**NEBRASKA ARMY NATIONAL GUARD
1776 BUILDING RENOVATION**

PROJECT NO. 31030098

A D D E N D U M N O . 1

1 LOWER LEVEL DEMOLITION PLAN

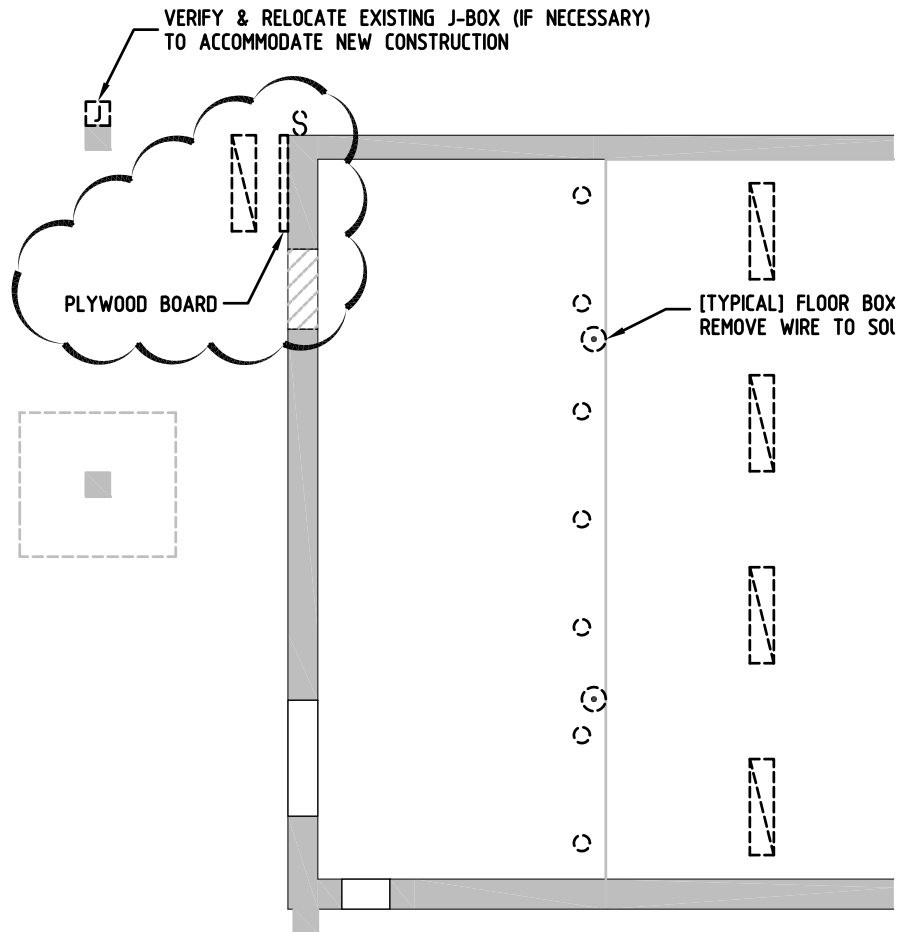
ADD E1-1: Sheet E0.1 - Lower Level Electrical Demolition Plan

- a) Plywood board/punch downs in crawl space to be removed. Roll up copper trunk lines & coil for future use. See attached drawing AD01.E01-1.
- b) Remove light fixture adjacent plywood board to accommodate new construction.

PLYWOOD BOARD/PUNCH DOWNS TO BE REMOVED.
ROLL UP COPPER TRUNK LINES & COIL FOR FUTURE USE
